# Rezoning Transportation Analysis

Petition Number: 2017-016

General Location Identifier: 16303224

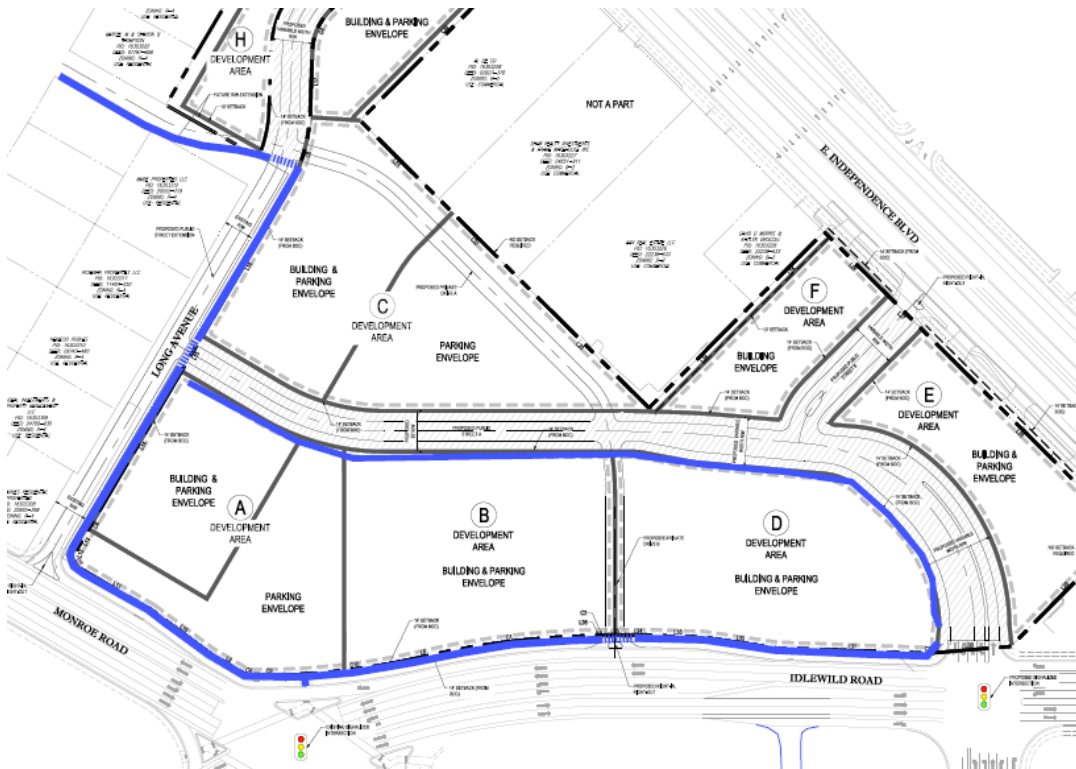
4. The petitioner should revise the site plan and the transportation notes to show installation of 12' wide sidewalk along all property frontages on Long Avenue, Monroe Rd., and Idlewild Rd. In addition, CDOT is requesting 12' wide sidewalk within the existing City right of way that exists between Long Avenue and Jerilyn Dr. Since sidewalks are required in these locations already (with exception to the paper ROW) CDOT is requesting that they be wider in these locations to accommodate the Independence Sidewalk and Bikeway project. CDOT recognizes that this is an added expense. However, CDOT feels that there is value to the developer to have the future multi use path run along the frontage of their property. This segment of 12' wide sidewalk could serve as a key segment to the future multi use path corridor that will be created by the ISB Project. This important multi use path will connect commercial uses in this area to residential neighborhoods for miles. If the wide sidewalk is not constructed with this project there is a good chance that whatever is built will be demolished and reconstructed at a later date by the ISB Project. Therefore CDOT feels it is practical to install the wider sidewalk as a part of this development. CDOT proposed 12' sidewalk as seen below represented by the blue line:
